Wake Stone Mining Permit 92-10 and its impacts William B Umstead State Park and on Protected Buffers required by the Permit

Buffers have been violated and DEQ has not taken action to require Mitigation, despite repeated complaints - significant adverse effects have now crossed over from the Buffers into William B Umstead State Park
The result is flooded parkland and dead mature trees

1988 Aerial
Photo of the
Site

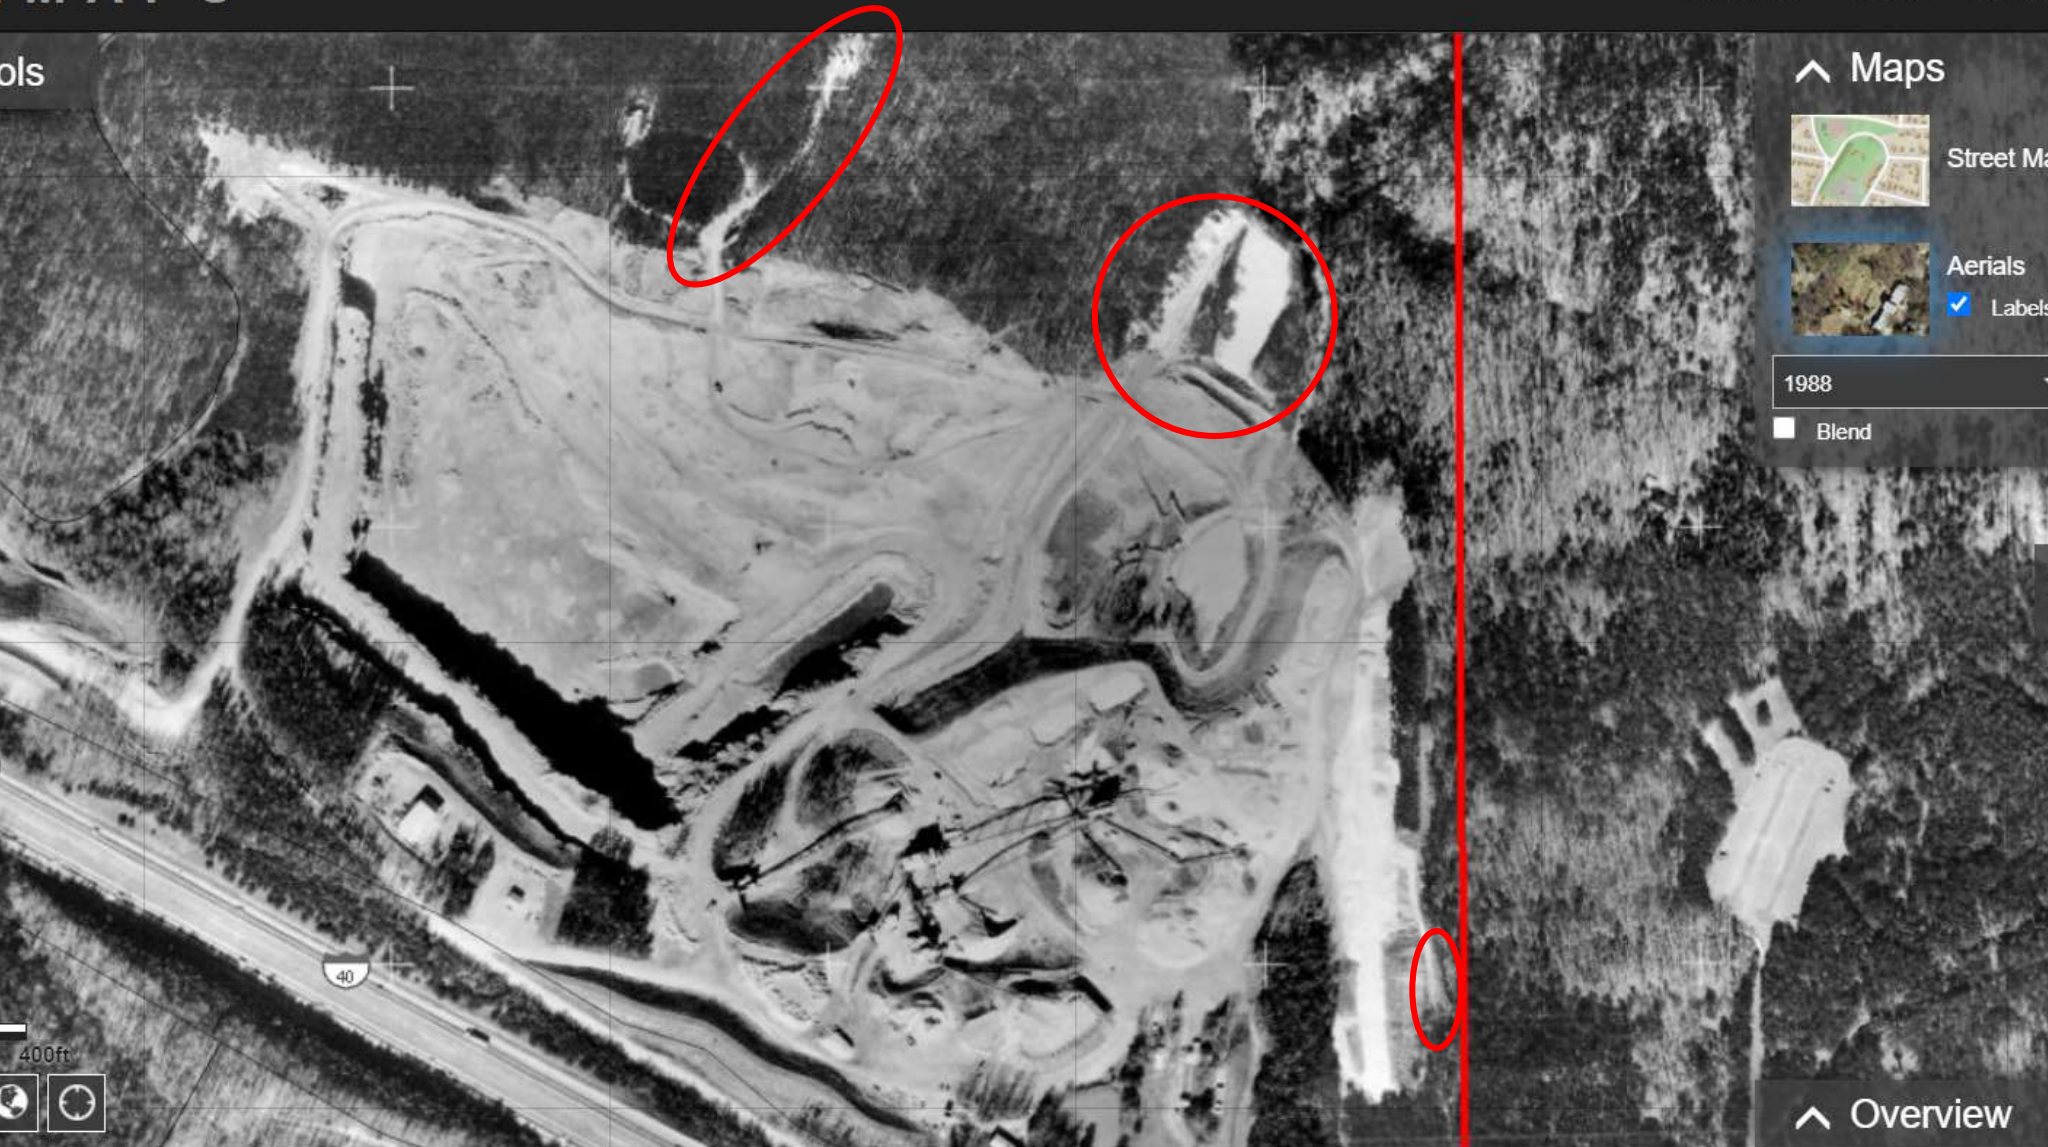
1988
Overlay of
1988 Aerial
photo and
1981
Approved
site plan
shows 3
Areas of
Buffer
violation

Rough estimated Overlay of the 1981 Site map showing protected 10 year buffer area North of the line, and 1988 IMAPS photo showing three large encroachments into the protected buffer.

1981 and 1986 Permit required an UNDISTURBED buffer zone of existing natural vegetation between the top edge of bank of Crabtree Creek and any mining disturbance, North of the 10 year buffer line.

On the east park boundary there was to be 50 foot undisturbed land between park boundary and the toe of the berm, this area was cleared within 10 feet of the boundary.

1988 Buffer Violations on North Buffer and East Buffer, Pond was latter approved after Wake Stone violated buffer, East was encroachment of 50 foot do not disturbed buffer when they built a berm that was to be located to leave 50 feet undisturbed buffer next to the Park, Wake Stone cleared 40 of the 50 feet.

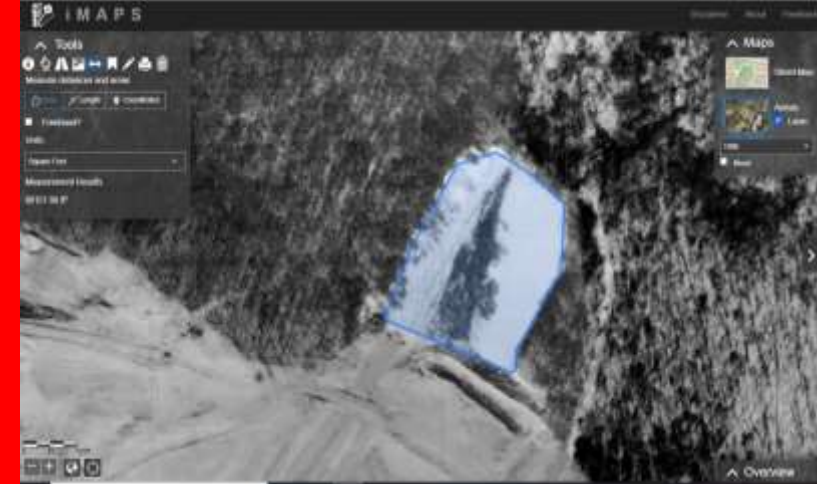
In the first 5 years of the 1981 Permit Wake Stone had violated the Northern permanent buffer

required by the both the Mining commission April 3

1981 Decision and the May 13, 1981 Permit conditions, which required an

UNDISTURBED BUFFER of EXISTING NATURAL VEGITATION.

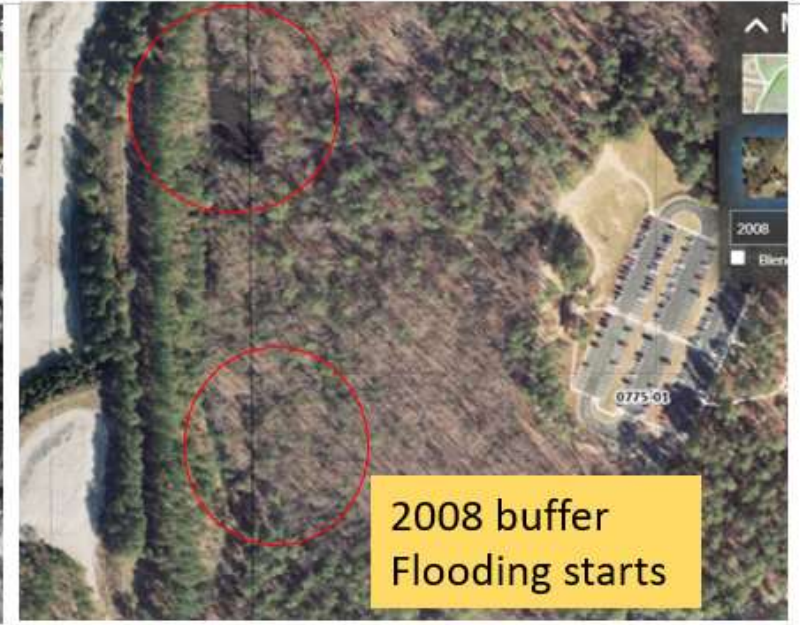
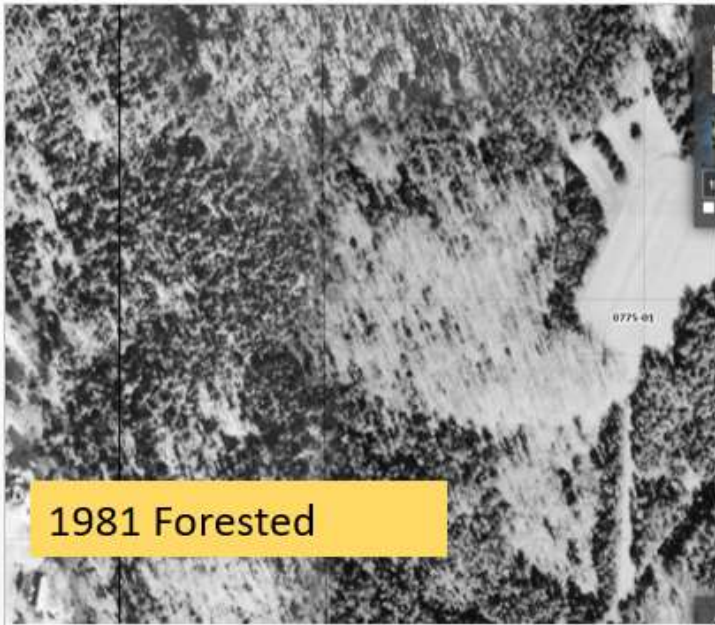
In the First year of the permit, 1982 Wake Stone Violated the 50 foot protected buffer during the construction of the Berm, They cleared within 15 feet of the Park Boundary

In 1982 State Parks objected to the buffer violation and reported flooding in the area that had filled the buffer and crossed into the park

Over the next 38 years the 100 foot protected buffer was flooded in two areas, killing all trees that were to be protected,

In recent years the flooding has crossed into the State park flooding parkland and Killing trees in the park.

Result of discharge into the buffer

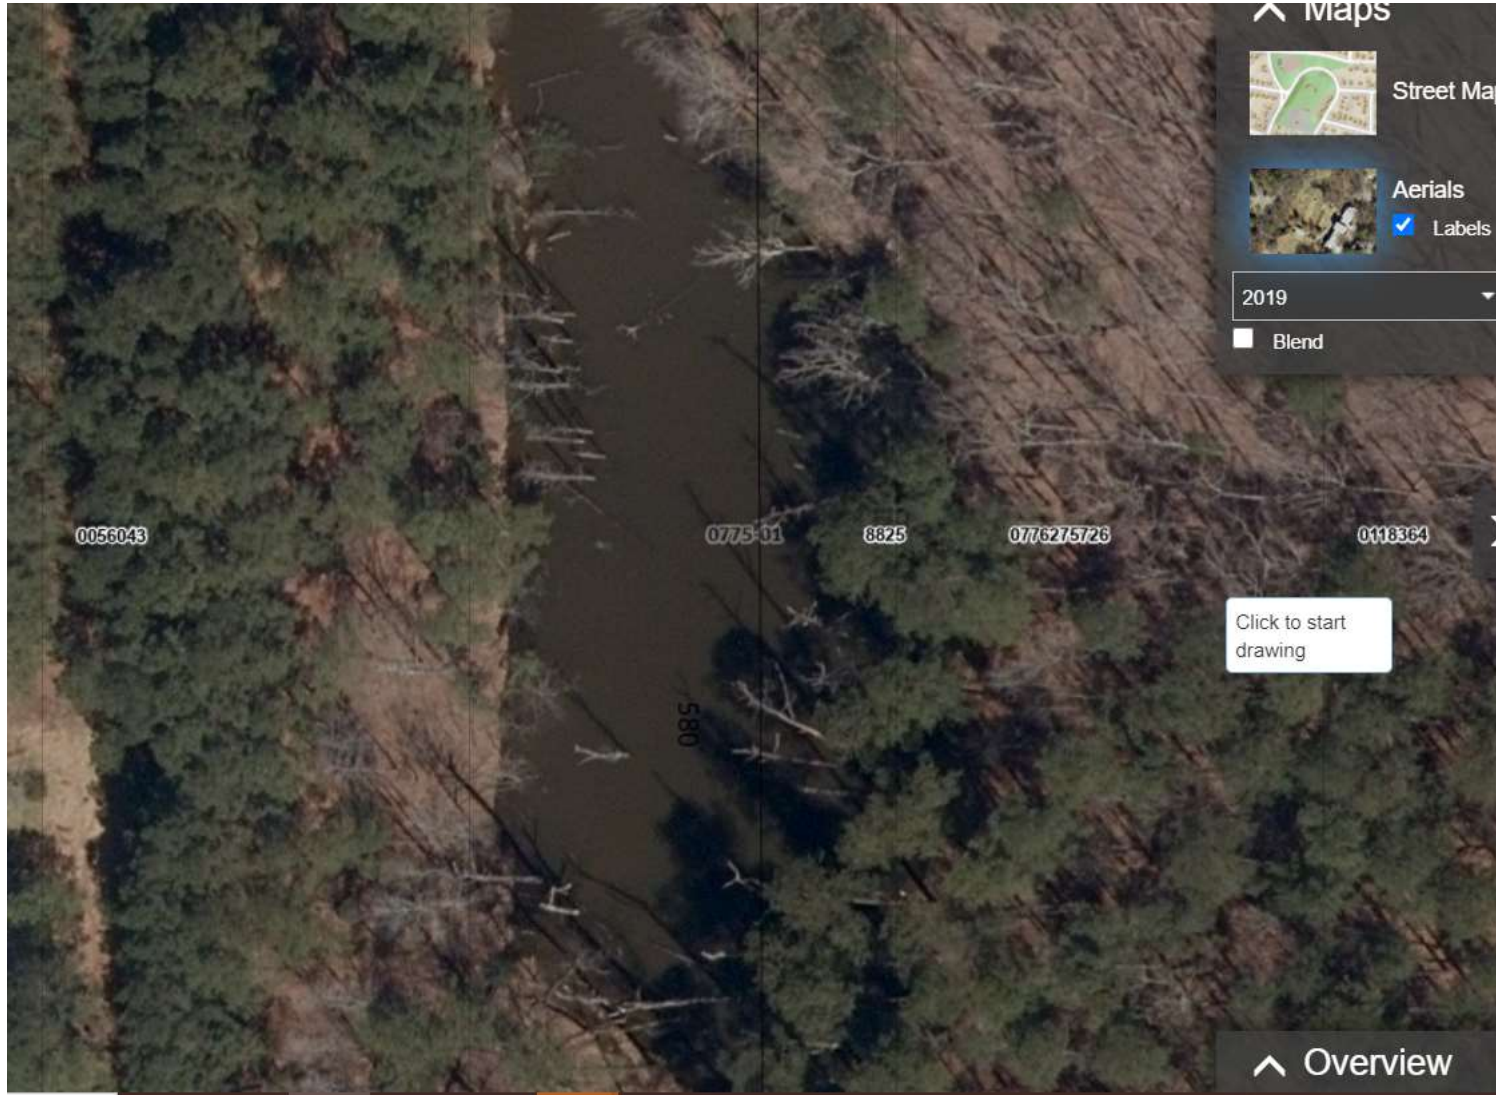
80 feet of 100 foot undisturbed buffer has been flooded

And the flooding has crossed over the park boundary flooding 60 feet into park property, killing all the trees in the flooded zone.

The damage and encroachment is continuing to grow over time

Here a second pond has been created in the undisturbed protected buffer, flooding 80 of the 100 foot buffer, and the flooding crosses into the park property flooding 30 feet into the park, killing all trees flooded

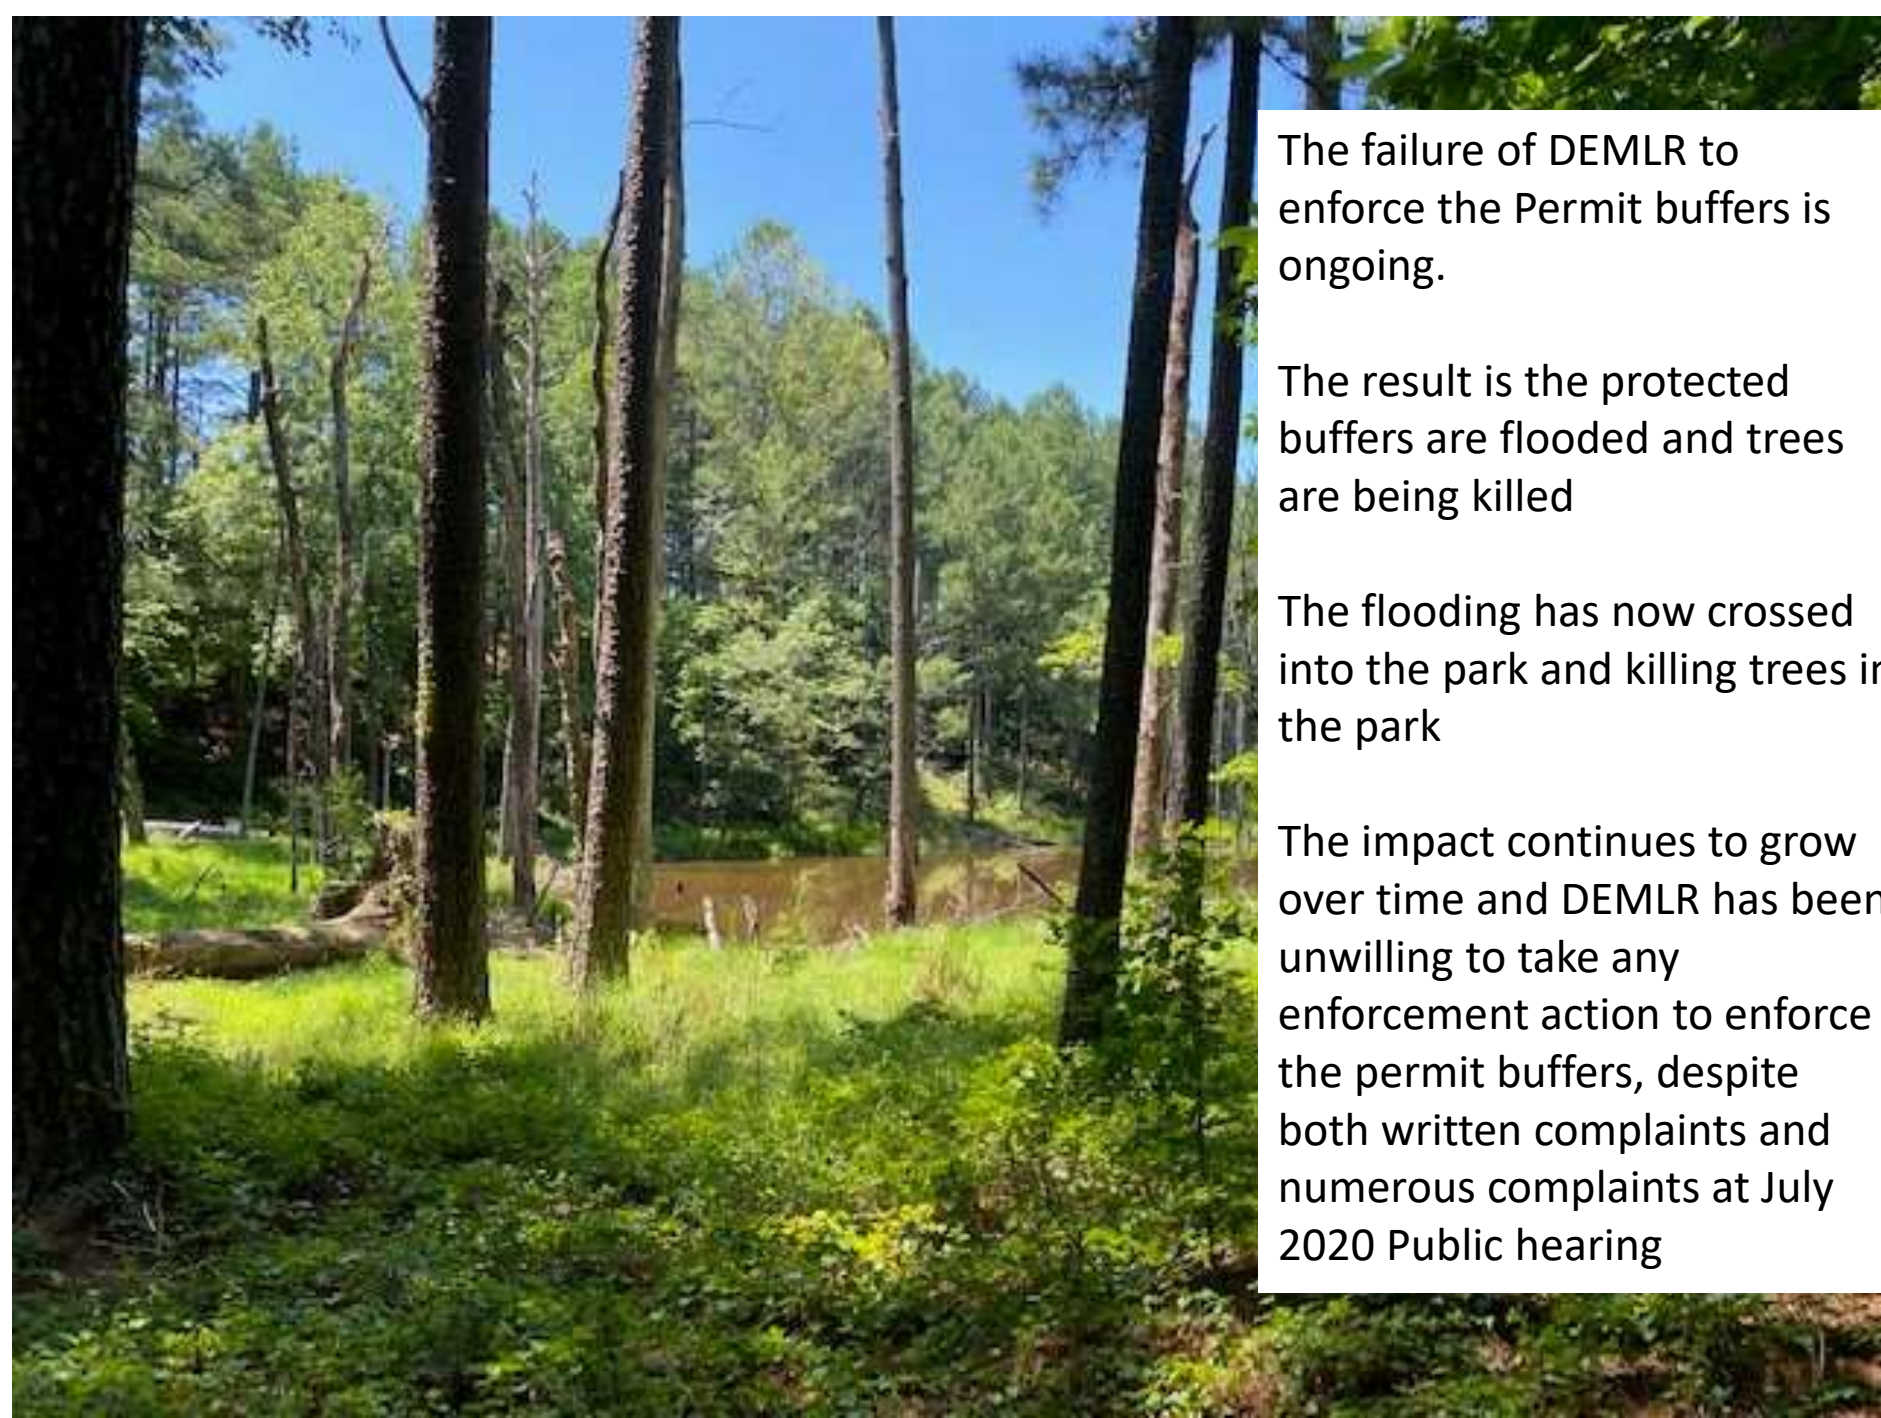
West Buffer Violation
1992 Blast too close to Stream destroyed natural buffer and filled Steam 90% blocking channel, red shape is buffer 7 years later still not revegetated, and blue line shows 100 feet from top of bank

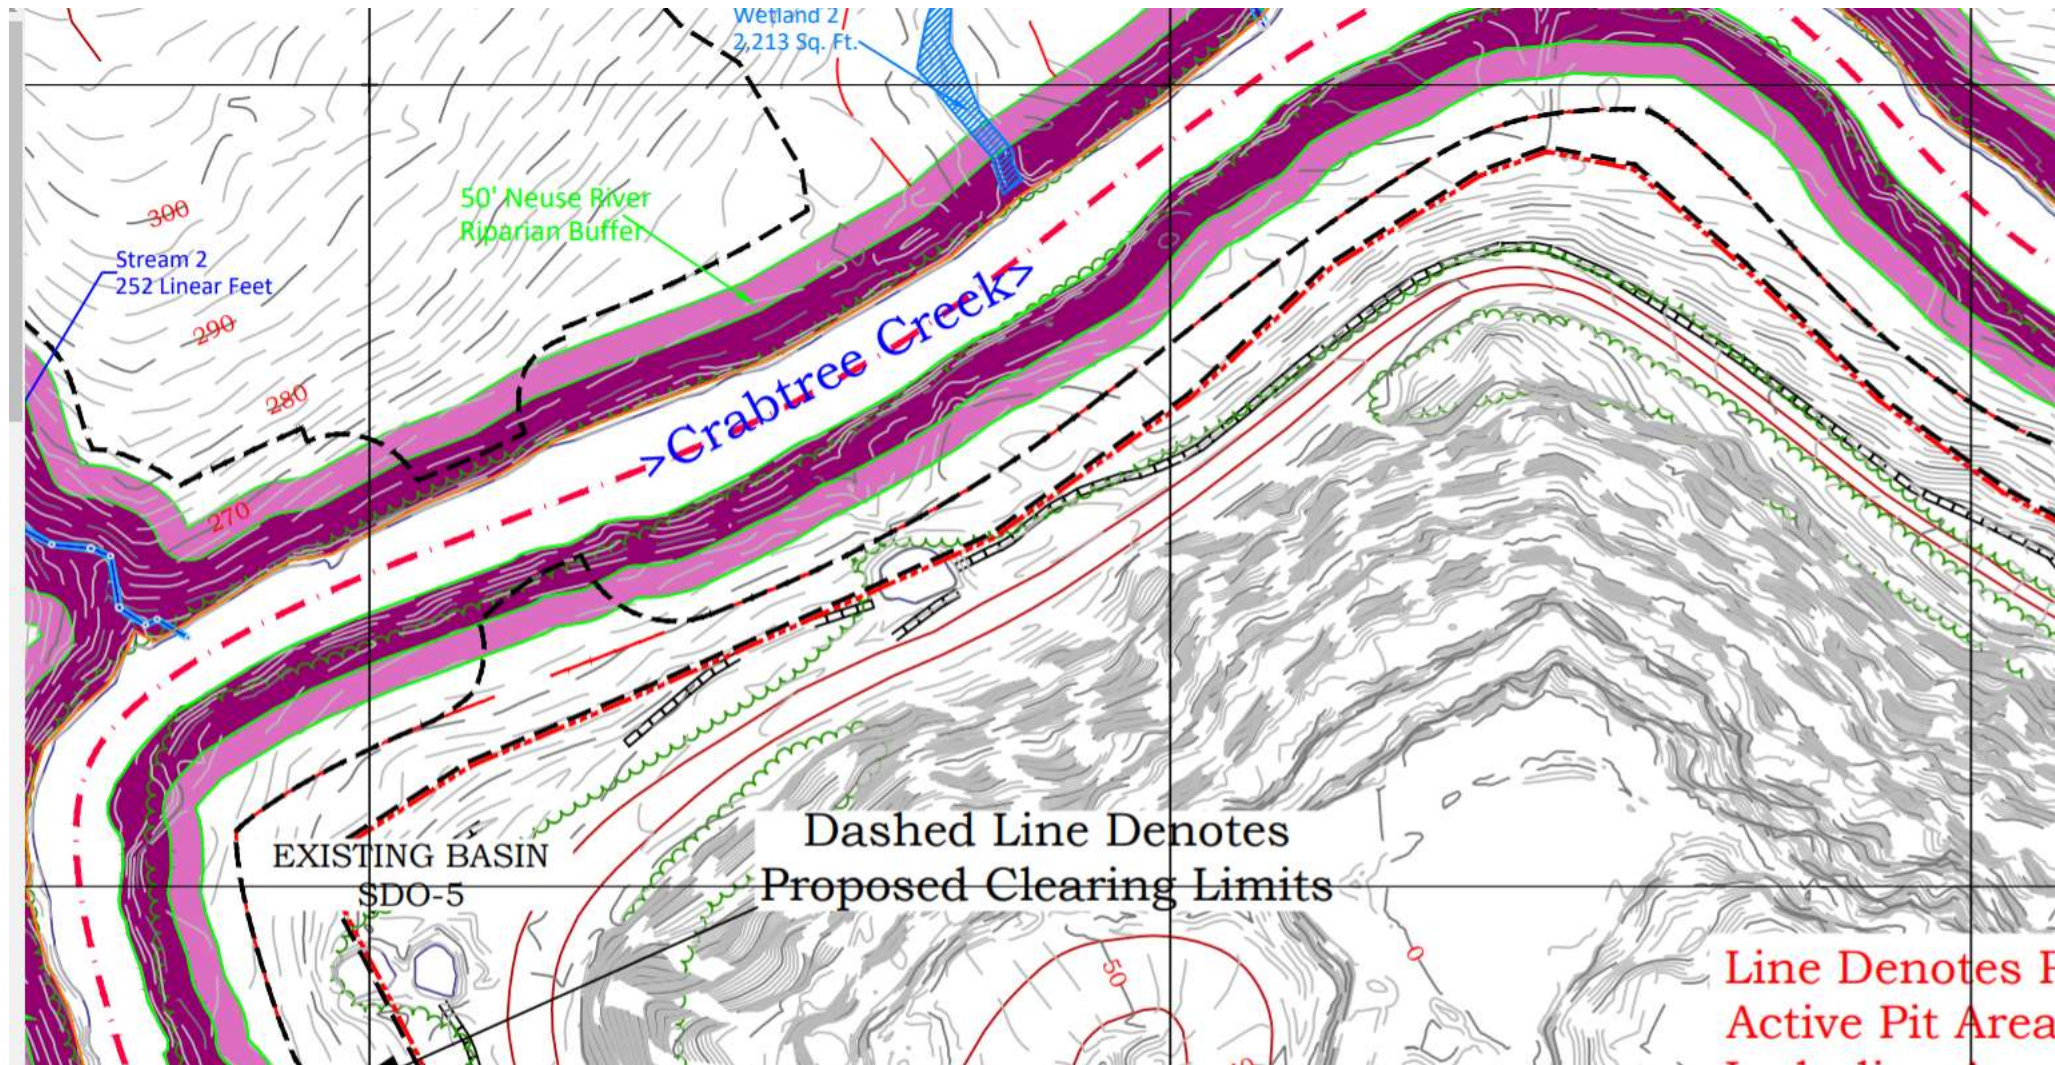
New Expansion request from Wake Stone Guts historical buffer widths from 250 foot undisturbed to only 25 foot undisturbed along the park Boundary, a 90% reduction in the UNDISTURBED buffer. Wake Stone violated the 1981 Buffers early and often, why should we trust they will respect these? DEQ never issued a Violation despite several blatant willful encroachments over the life of the existing mine.
